New Reactors Programme

GDA close-out for the AP1000 reactor

**GDA Issues GI-AP1000-FS-03 “Diversity for Frequent Faults” and GI-AP1000-FS-04
“Provision of Enhanced and Diverse Flux Protection to Protect against Adverse Power
Distribution Faults”**

Assessment Report: ONR-NR-AR-16-024
Revision 0
March 2017

Figure 1: Simplified drawing of the **AP1000** secondary system

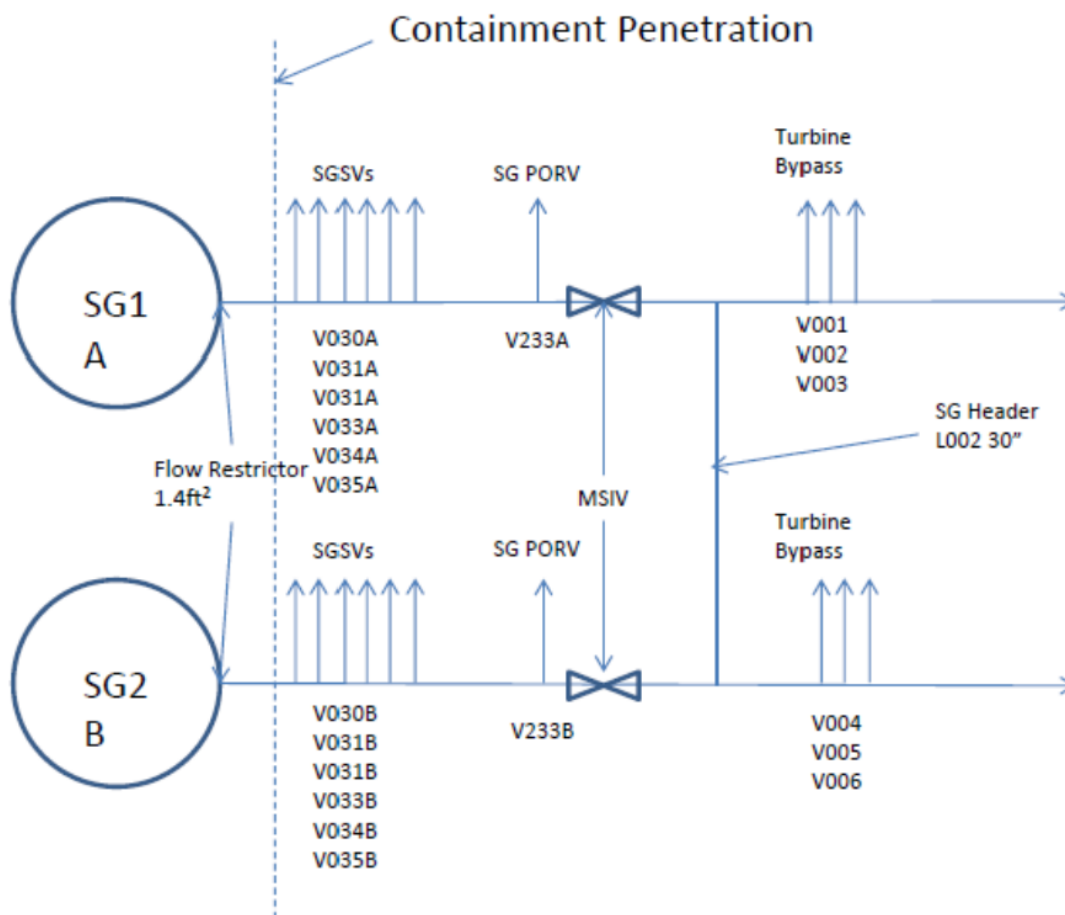
74. Figure 1 shows a simplified diagram of the **AP1000** secondary system that Westinghouse has reviewed to identify both pipe breaks and valve openings. It has considered both Electric Power Research Institute (EPRI) pipe rupture frequency references and similar material issued by the Health and Safety Executive (HSE) to

75. Westinghouse has also looked at available data for the mechanical failure of valves in the secondary side. It has concluded that the failure of a single valve is $< 1 \times 10^{-2}$ per year, and therefore the independent failure of two valves is $< 1 \times 10^{-4}$ per year. The valves are sized such that none have a flow area larger than 0.018 m^2 (0.2 ft^2) and therefore the failure of two valves in the same line is bounded by the break fault mentioned above. I am satisfied with this approach. Attributing frequencies to breaks or valve failures is not a precise science, and by considering larger breaks or multiple failures that have a calculated frequency down to 1×10^{-4} per year (the definition of a frequent fault being 1×10^{-3} per year), Westinghouse has taken reasonable steps to consider 'cliff-edge' effects (see SAP FA.7) while still eliminating the largest breaks from its ATWS evaluations.

76. Westinghouse has also considered C&I-induced failures of the Power-Operated Relief Valves (PORVs) or the turbine bypass valves (the steam generator safety valves are spring loaded). The consequences of both PORVs opening because of a PMS failure are the same as a mechanical failure. The potential for all six turbine bypass valves opening is a more complex situation. The flow capacity of each turbine bypass valve is 6.66% of the rated main steam flow at full load, resulting in an excessive load increase of up to 40% if they were to open spuriously. This would be a severe and limiting symmetric fault if it ever occurred. However, Westinghouse states in Ref. 22 that it would require a highly unlikely combination of PLS and PMS faults for the sequence to occur. I am sympathetic to this assertion but it is a complex claim to substantiate. I therefore suggested to Westinghouse during my routine interactions on this GDA Issue that it could be a simpler and stronger safety case to demonstrate the resilience of the **AP1000** design to such an event rather than trying to justify its exclusion. Westinghouse has chosen to do this.
